SUNDRY NOTICES AND REPORTS ON WELLS

XTO Energy would like to propose the following procedure for repairing a csg lk:

COUNTRY/STATE: LEA, NM
LEASE: EUNICE MONUMENT
CURRENT STATUS: INJ
COMPL DATE: 10/15/37
API No: 30-025-04312

WELL NAME: EMSU B #897
LOCATION: 660' FNL & 1980' FWL, SEC 24, T20S R36E
FORMATION: GRBG
SPUD DATE: 09/14/37
IP:

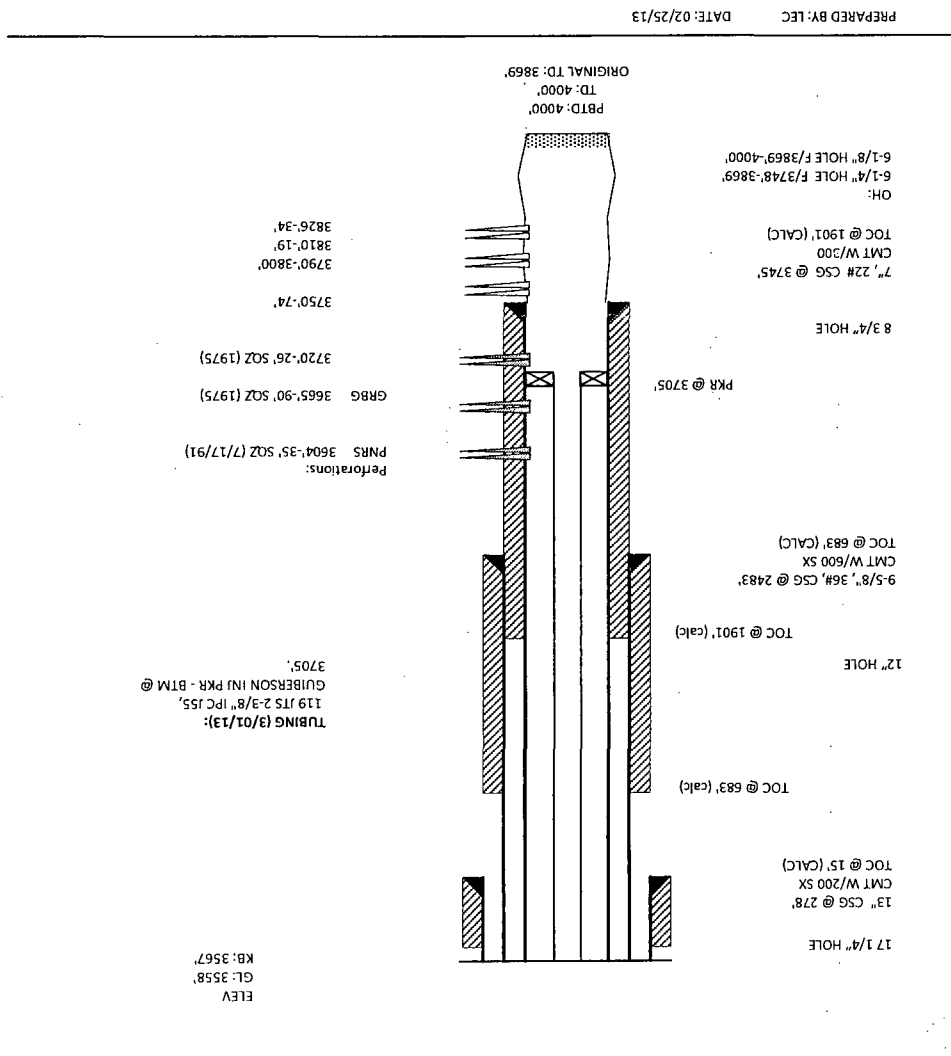
1. MIRU PU.
2. Isolate csg lk w/a 7" RBP & pkr.
3. Set RBP +/- 50' below lk, dump sand & tag.
4. MIRU cmt comp. Pump 14.8ppg class C cmt using balanced plug across lk interval w/ +/- 100' cmt above top lk loc.
5. Press to 500psi.
6. SION w/500psi on sqz.
7. Test to 500psi for 15-30mins.
8. DO/CO cmt, sand and RBP out of well.
9. Run a good chart.
10. RWTI.

CONDITION OF APPROVAL: Operator shall give the OCD
District Office 24 hour notice before running the MIT test and chart.
